## PLAN COMMISSION

October 22, 2019

## PLAN COMMISSION REPORT

Proposal: Plan Review – Ambulatory Surgery Clinic

**L100**

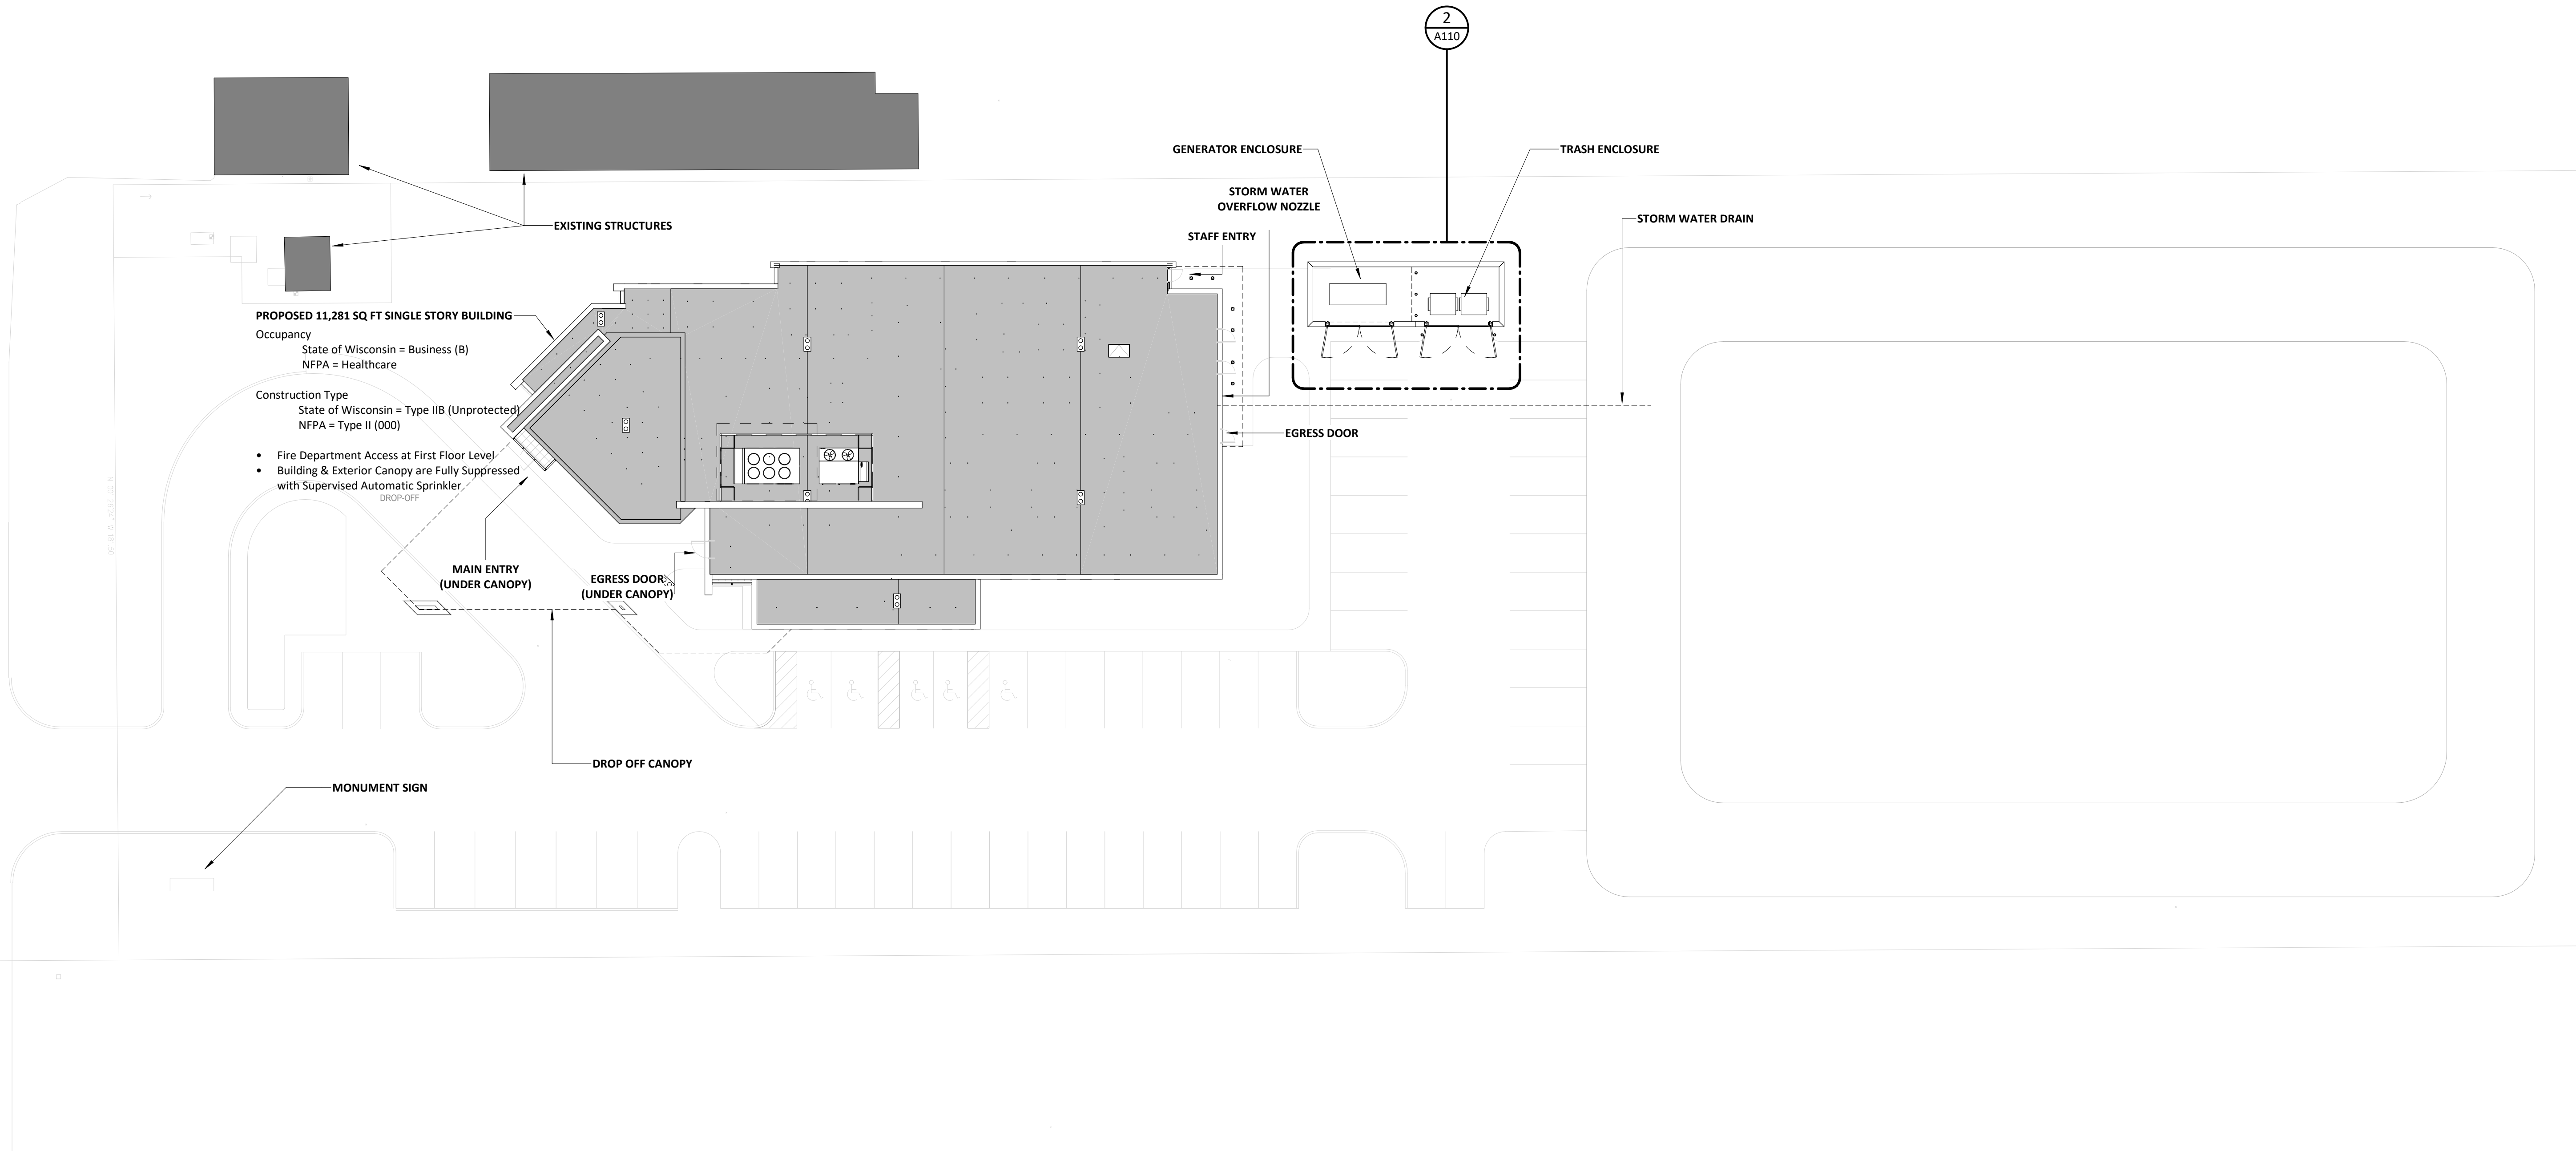
One combination trash and generator enclosure is proposed adjacent to the northeast portion of the building. Proposed materials include brick veneer to match the building and metal gates (facing south). Landscaping is recommended around the north portion of the enclosure to further screen from the property to the north. Staff has spoken to and will continue to work with the Applicant's consultants to ensure that revised landscape plans incorporate additional plantings on the north elevation and elsewhere onsite in compliance with Code requirements.

6. That the landscape plan is revised to incorporated plantings on the north portion of the property, around the proposed monument sign location, and as necessary for compliance with Code requirements. Plants used to screen parking areas from rights-of-way must be installed and maintained at a minimum height of 3 feet.

**A220**

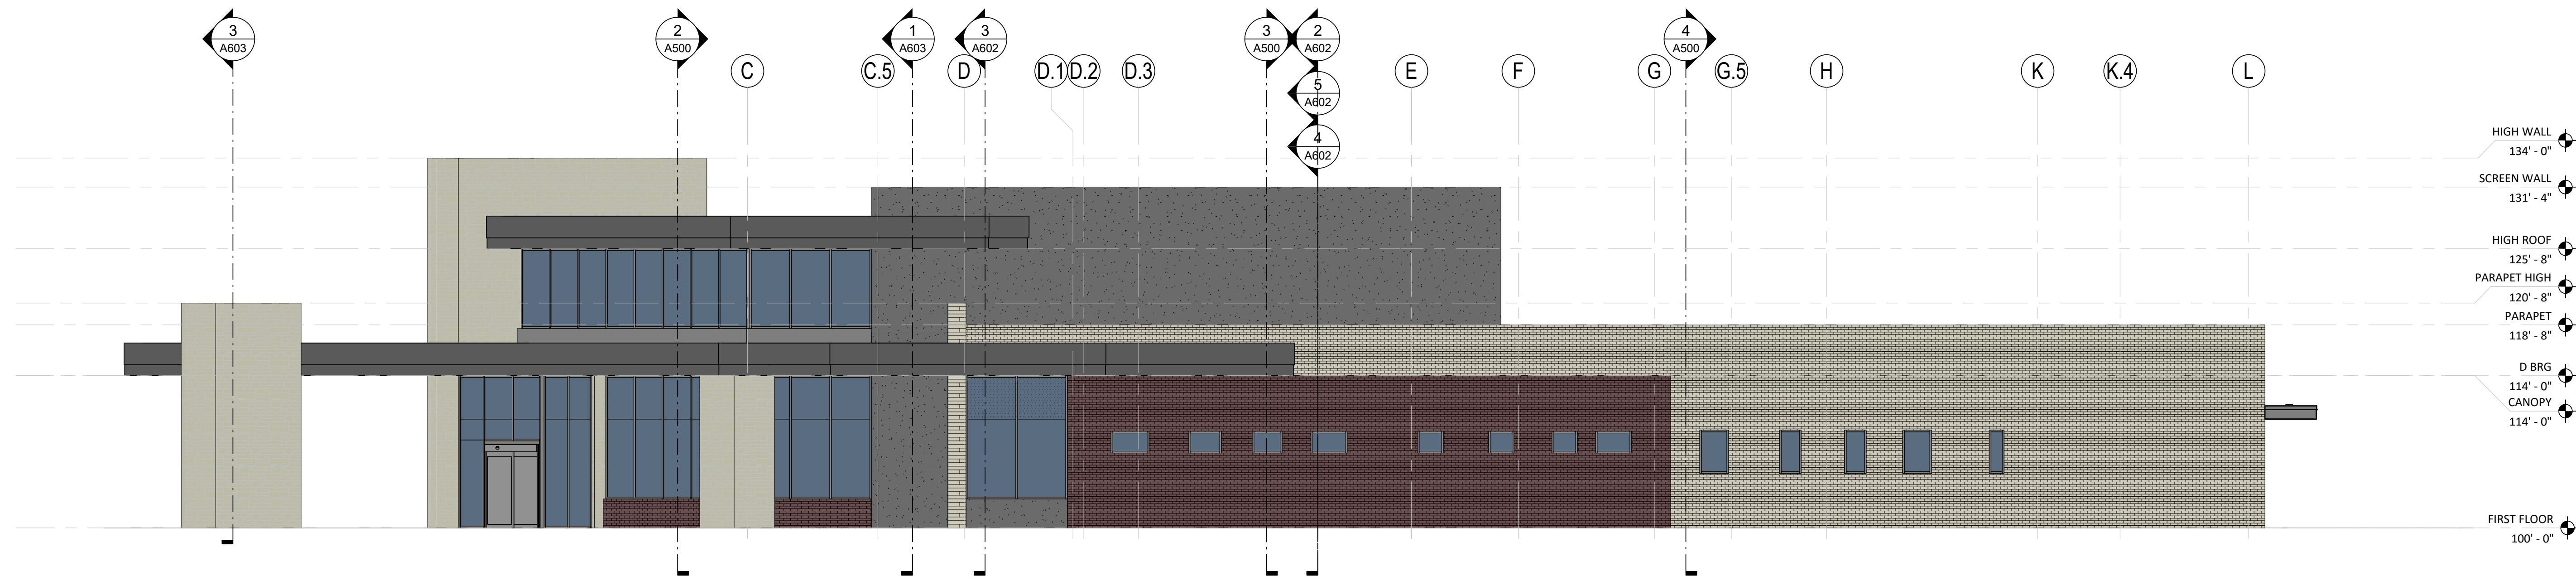
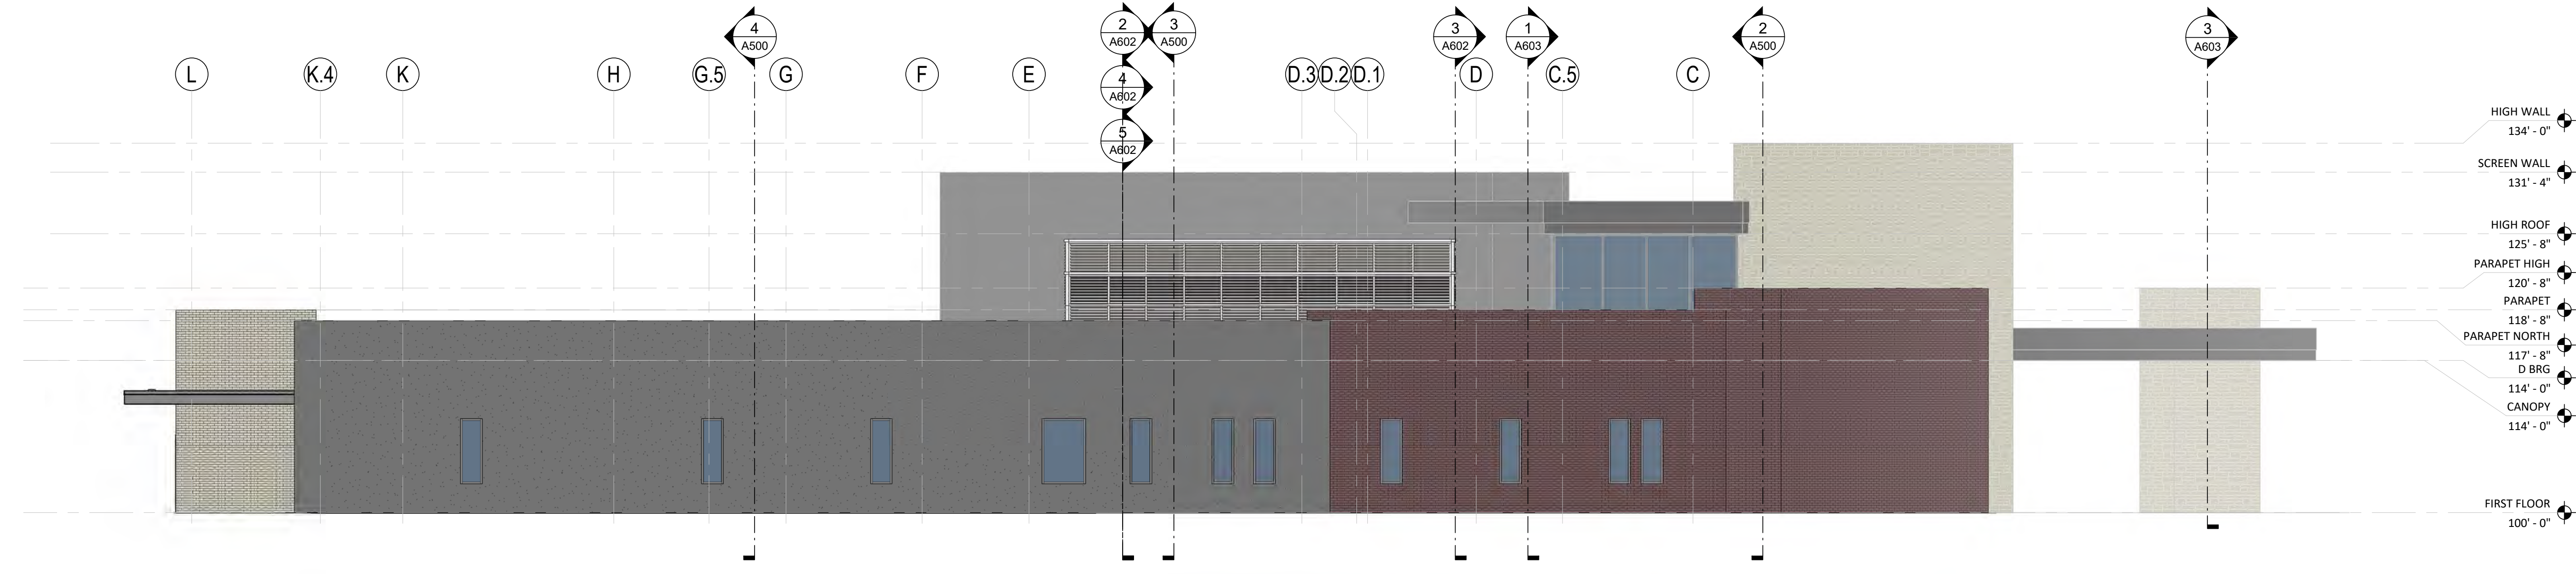
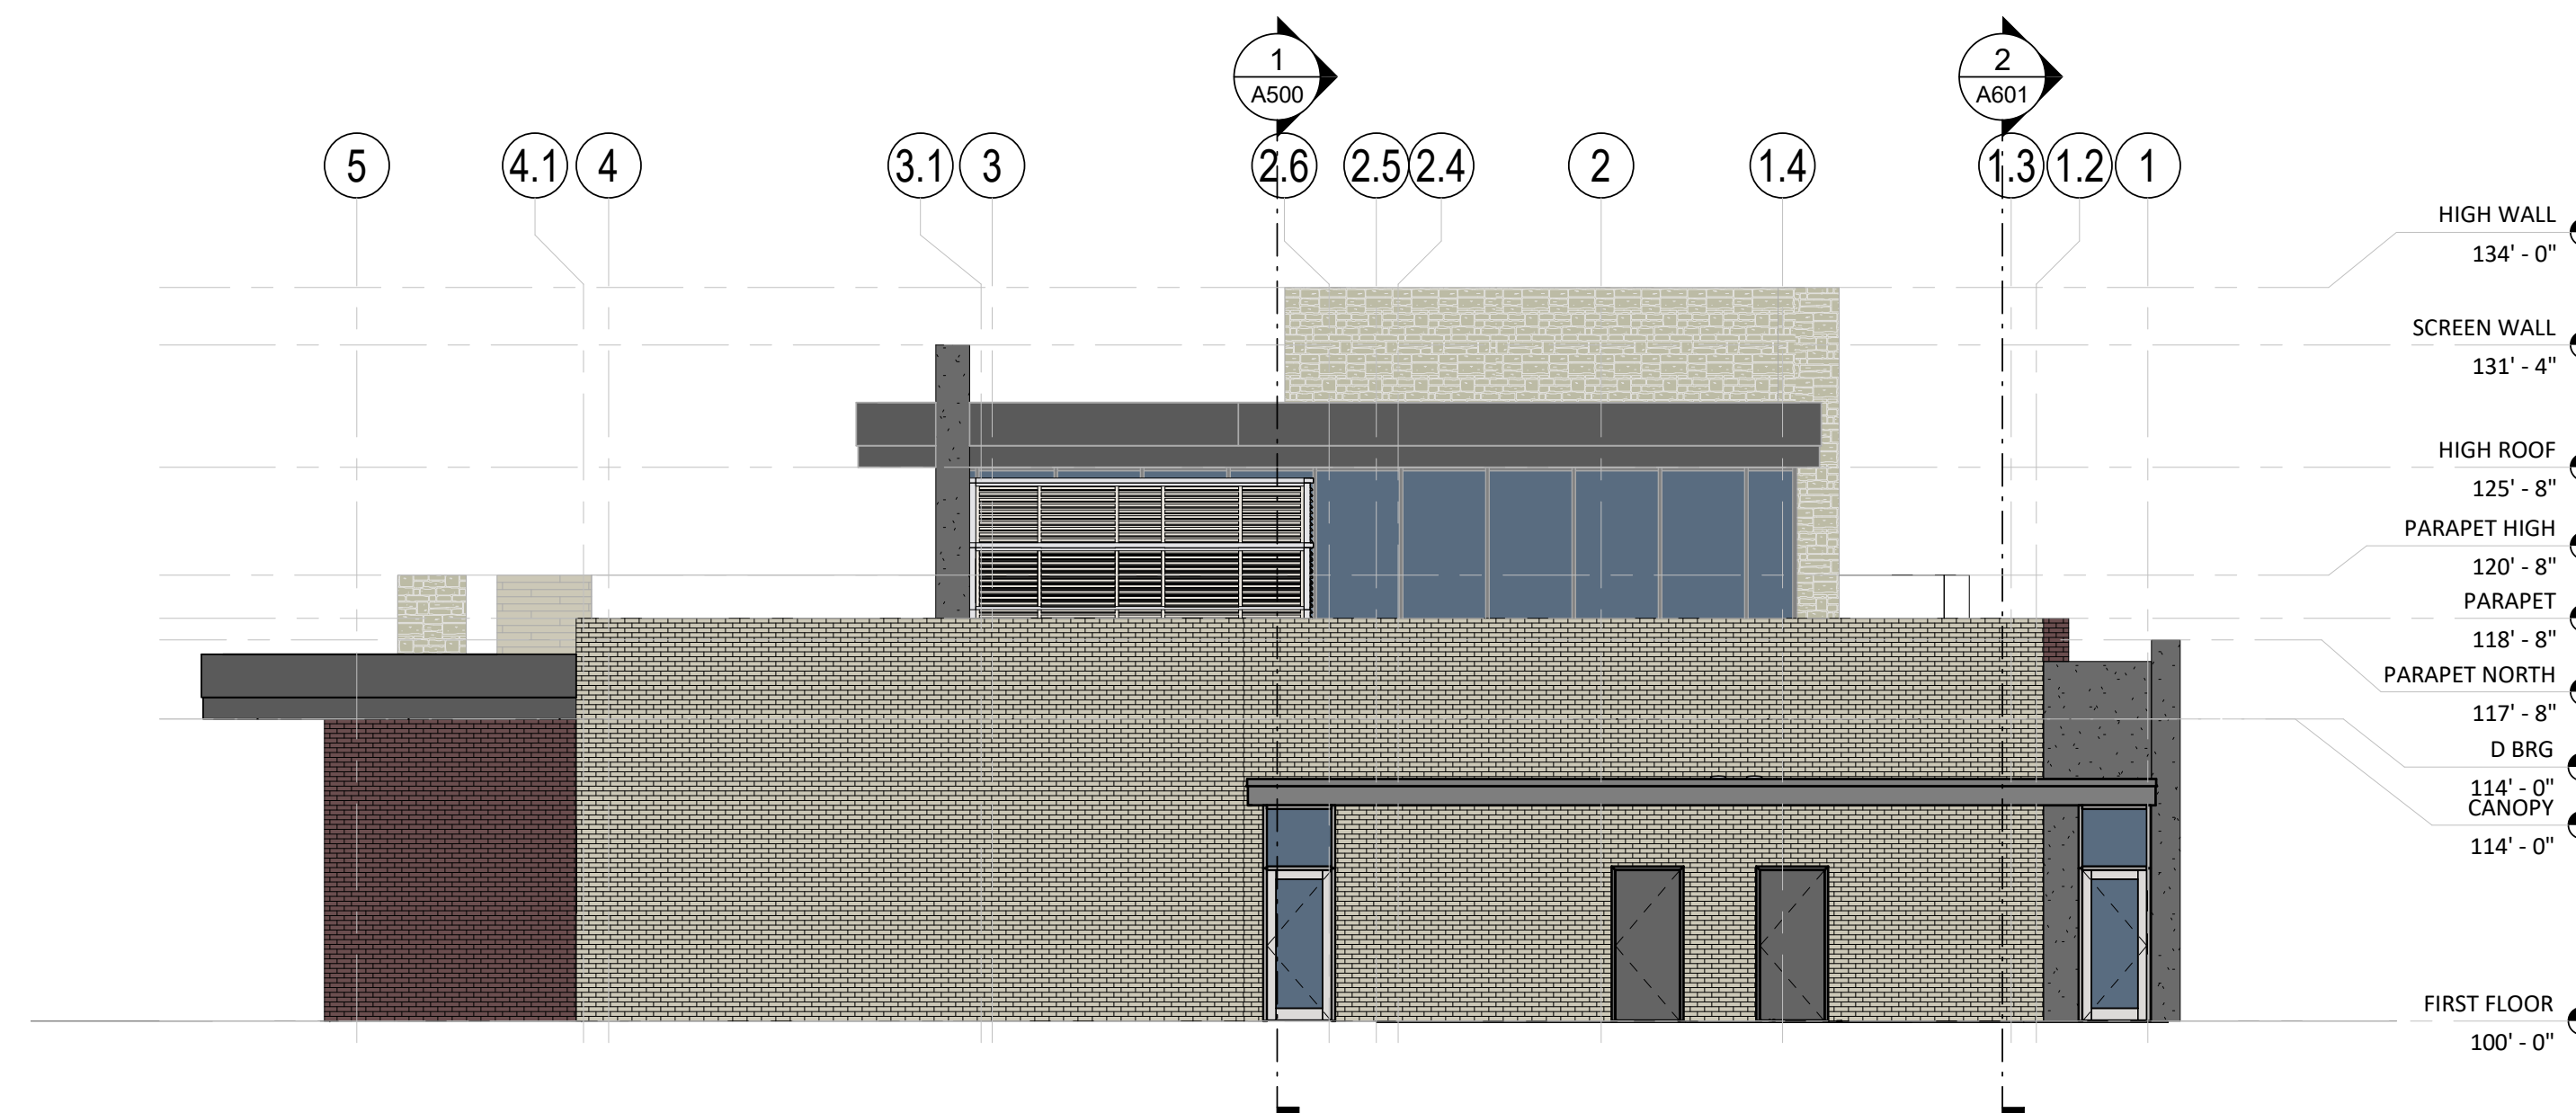
Insulated and spandrel glass panels are proposed on all elevations, although from the submitted elevations it is difficult to distinguish between the two materials. Metal and stone canopies are proposed over main entrance on the west elevation, and a metal canopy is proposed over all doors on the east elevation. Rooftop mechanical units, shown on the Building Sections and Electrical Site Plan sheets, indicate that they will be

sited toward the center and west portion of the roof, and screened with a decorative metal screen. All ground, building, and rooftop mechanical units, utility boxes, and transformers must be screened per Code. This has been included in the recommended conditions of approval above. Materials percentages for all exterior building materials, with the exception of the rooftop mechanical screen, are shown on the elevation sheet.

- As previously discussed, the majority of the building will be constructed with brick, stone, and glass. EIFS comprises a majority of the north elevation. The remaining subsections of Section 17.0329(c)(2)(c) appear to be met in the plans. Staff would like the Plan Commission to specifically make a determination on the proposed use of spandrel glass, including the location(s).

3. That the exterior brick and stone veneer meet the minimum 4-inch thick requirement per Code.
4. That the color of the spandrel windows shall not be a dark or mirrored glass per Overlay District standards, and shall be specified on the final plans.

5. That the plans are revised to include locations for all mechanicals, transformers, and utilities. That all mechanical equipment, transformers, and utility boxes (ground, building, and rooftop) are screened from view.
